Service BULLETIN

**APPLICABLE TO 64348, 64349 & 64049
NOZZLES AS OUTLINED BELOW**

**SB3480801A
Nov. 1, 1998**

REVISION TO AUGUST 1, 1998 BULLETIN! NEW TWO-PIECE HANDLE BREAKAGE REPORTED

FIGURE 1

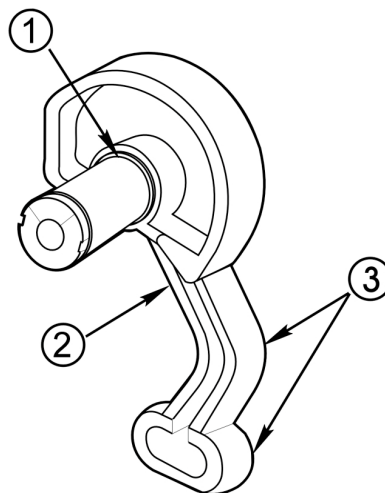
It has been reported that several of the newer 220878-1 handles have been broken on nozzles installed on hose reel applications. Reports of leakage from the handle shaft area were initial signs of breakage. Reports of the single screw coming loose were also signs of the breakage. The handle is an integral part of the nozzle interlock system. The breakage, result of mishandling (dropping), has occurred at a machined radius area “1”, as shown in Figure 1 on the next page. If not detected, further use can cause

the handle to loosen and overcome the interlock system. The result can then be a possible spill since it can then be possible for the operator to take the nozzle off of the aircraft with the nozzle poppet in the open position. The breakage has been the result of impact on the handle in the areas marked with a “3”, Figure 1. The handle first bends until it contacts the carrying handle or sometimes the bolt head attachment of it. The bolt head impact results in an impression in the handle and produces a stress riser in the area marked “2” which may result in the handle breaking at that point. This is a maintenance problem but not a safety issue. Further impacts in the areas marked “2” and “3” can result in the fracture at “1” which is the object of this bulletin. All operators should be provided the following information (instructions) to prevent spills and possible bodily injury from spilled fuel:

1. **No nozzles, to our knowledge, have had a handle breakage problem where they are installed on a deck type application; hence dropping is a major contributor to the problem. Even though it has been done in the past, another caution not to drop the nozzle should be extended to the operators.**
2. **If fuel leakage, no matter how slight, appears from the area of the operating handle do not use the nozzle. Take it out of service immediately. Inspect the handle for evidence of a crack at “1”. It may start out as a very minute crack and may be difficult to see with the eye. Replace the handle if not certain.**

If the handle or attaching screw appear to be loose, DO NOT ATTEMPT TO TIGHTEN THE SCREW, you will only cause the insert in the crank to be damaged. Remove the nozzle from service immediately.
